1. REPORT DATE <b>16 DEC 2010</b>		2. REPORT TYPE		3. DATES COVERED <b>00-00-2010 to 00-00-2010</b>	
4. TITLE AND SUBTITLE <b>B-2 Bomber: Review of the Air Force's Decision to Change Extremely High Frequency Satellite Communications Antennas</b>				5a. CONTRACT NUMBER	
				5b. GRANT NUMBER	
				5c. PROGRAM ELEMENT NUMBER

*Subject: B-2 Bomber: Review of the Air Force's Decision to Change Extremely High Frequency Satellite Communications Antennas*

## **B-2 Extremely High Frequency (EHF) Satellite Communications (SATCOM) Increment 2 Program Acquisition Approach**

**Figure 1: Antenna Options Assessed in Air Force Trade Study**

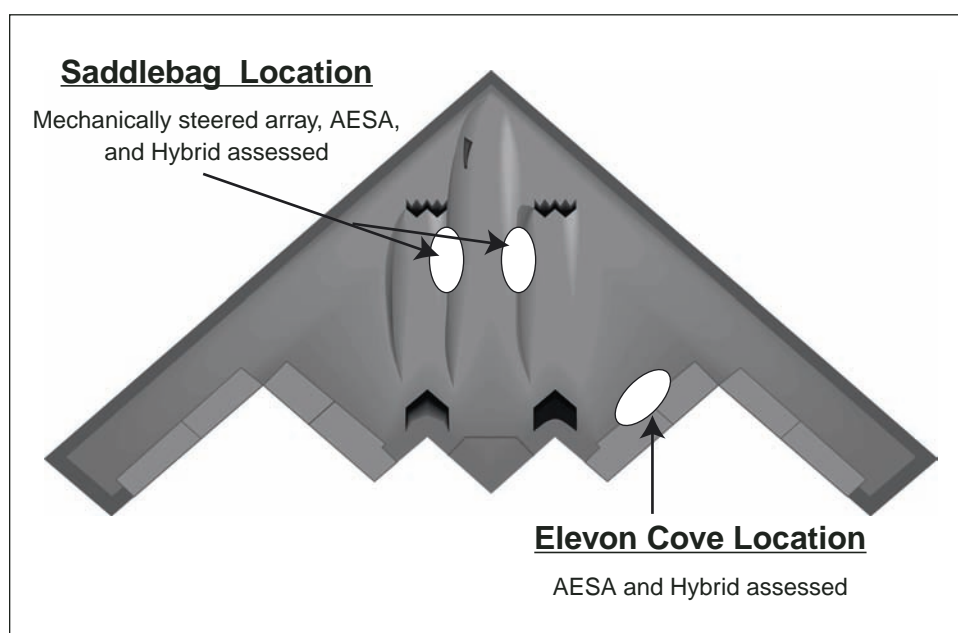
Air Force assessments by the ASC Structures Branch and an ASC Acquisition Center of Excellence panel also supported changing the antenna location on the aircraft. The Structures Branch assessment, led by a former B-2 structural engineer, found that integrating an antenna system into the saddlebag location would be more complex and higher risk primarily because of the engineering required and aircraft modification challenges. The ASC Acquisition Center of Excellence panel, comprised of subject matter experts from the Air Force acquisition, manufacturing, and technology development communities, concurred with changing antenna locations from the saddlebag to the elevon cove and noted the rigor of the process used by the program to make this decision.

**Figure 2: Trade Study Antenna Options**

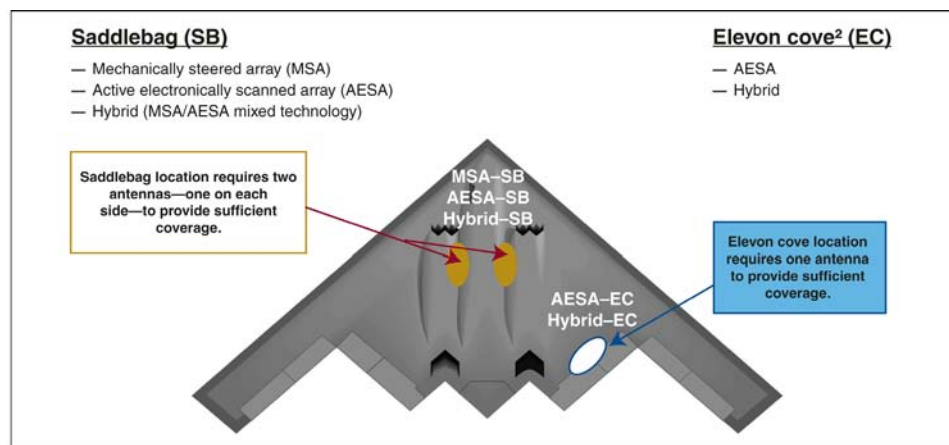
- The trade study determined that requirements needed revision because no antenna subsystem concept could meet all four KPPs as drafted in the capabilities development document.

- Its assessment of B-2 EHF antenna locations and technologies determined:
  - All antenna location and technology options assessed were viable but carry different risks and technology maturity timelines.

- Antenna location for integration much more of a determinant than expected. Elevon cove location reduced integration risk compared to the saddlebag.

- Radar cross section did not dictate a specific antenna location or technology change, but a move to the elevon cove could reduce the effect on aircraft low observable qualities. Low-probability of intercept/detection options of AESA matched or exceeded MSA results.

- Although the study assessed all options as viable, from the program's perspective it provided evidence that an alternate location and technology exists that has lower integration risk than the MSA in the saddlebag option.
